SIZZLER BULLETIN

DATE: JUNE 3, 1985
TO: ALL SIZZLER OWNERS
SUBJECT: CABBAGE HEAD EARS

DESCRIPTION: CABBAGE HEAD EAR & CABBAGE HEAD

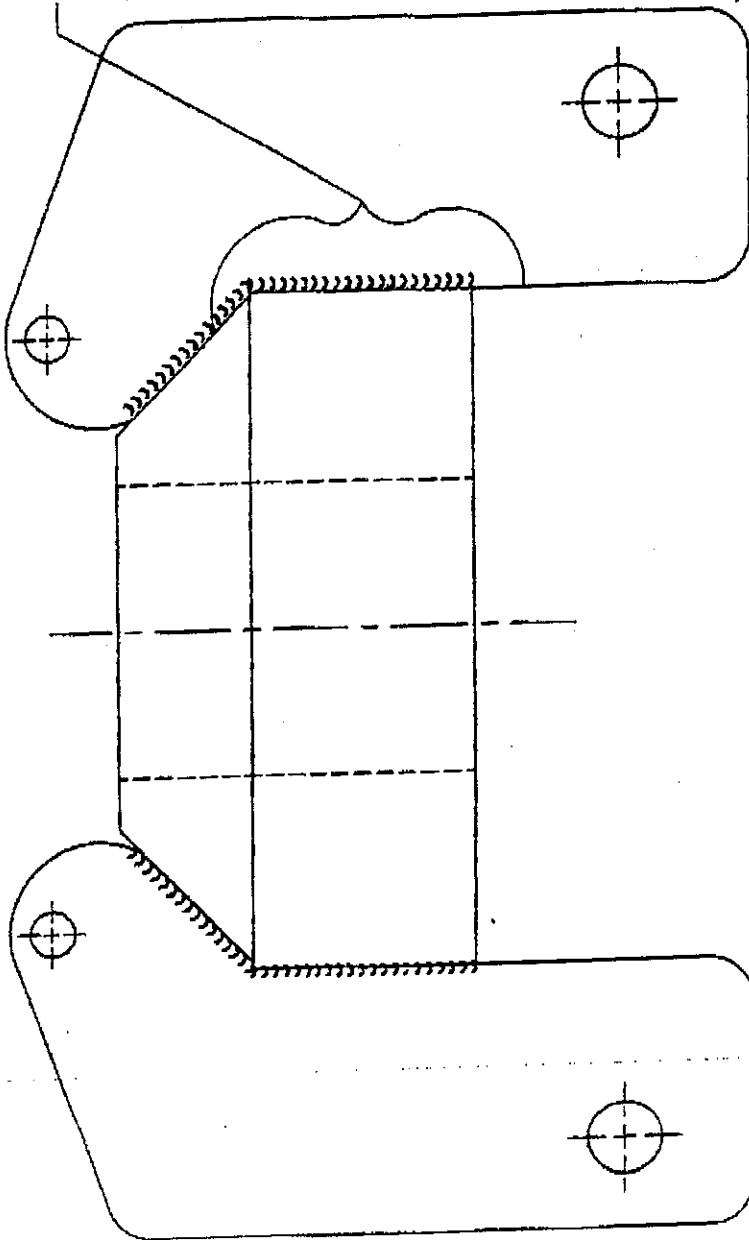
Due to reports of cracks in the cabbage head ears, it is required to annually Nondestructive Test the cabbage head ears for cracks.

- Step 1 Remove the cabbage head safety plates.
- Step 2 Remove the paint in the area of the weld and contact areas for the magnaflux unit.
- Step 3 Inspect the welds and ears for cracks.
- Step 4 Repaint where the paint was stripped.
- Step 5 Reinstall the cabbage head safety plates.

Any cracking that is discovered in the weld only can be grooved out and rewelded.

Any cracking in the ear requires replacement of the entire ear.

AREA TO MAGNAFLUX
ANNUALLY FOR CRACKS.
VISUALLY INSPECT EACH
WEEK.

Perform this inspection on an annual basis.

Carrying passengers in a car with a cracked cabbage head ear is not allowed until the ear has been replaced or rewelded according to the above procedure.
